**DOCUMENT ID #:** 21-0492

**REVISION:** E-000

**DOCUMENT TITLE:** PACKAGE OUTLINE, 144 BALL CTBGA, 10X10X

**CHANGE NUMBER:** 1188197

BOTTOM VIEW

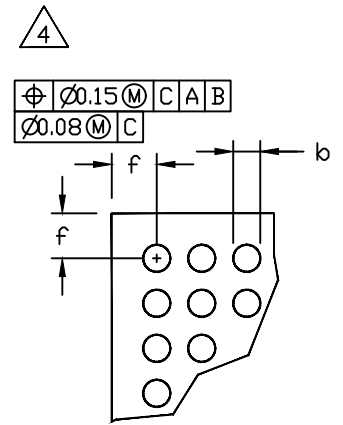
REV	CHANGES MADE	DATE	INIT.
A	ECN# HQ-10-0911. INITIAL RELEASE.	05/11/10	GP
B	ECN# HQ-12-1759. PIN NUMBERING WAS CHANGED IN BOTTOM VIEW DIAGRAM: A THRU M ARE NOW SHOWN ON DIMENSION D SIDE 1 THRU 12 ARE NOW SHOWN ON DIMENSION E SIDE	08/09/12	GP
C	CN# 1001603 ADD NEW PKG. CODE(X14400+6C)	11/05/15	AG
D	CN# 1012430 ADD NEW PKG. CODE(X14400+7C)	03/03/17	BG
E	CN 1188197. ADDED X14400+9C	06/05/23	BG
